City of Santa Fe, New Mexico

memo

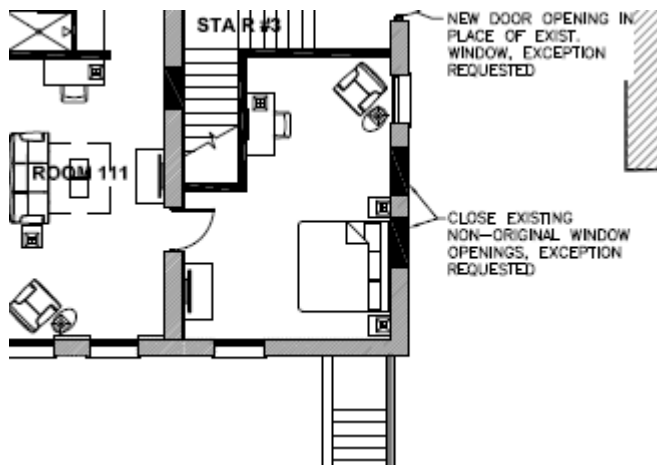
Applicant Response: *Allowing this exception strengthens the unique heterogeneous character of the City in several ways. Changing the façade by closing some existing openings allows the opportunity to offer a design solution that is centered around authenticity, rather than a “false façade” approach. It allows for an adaptive reuse of this building that respects its history and also does not try to hide its evolution over time. These necessary changes to the façade will contribute to a successful adaptive reuse of a vacant building, which has been the subject of vandalism. Bringing this building back to life will have a positive impact on the residents of the Historic Districts. The windows in question are not original openings, as can be seen in photo Exhibit 4.*
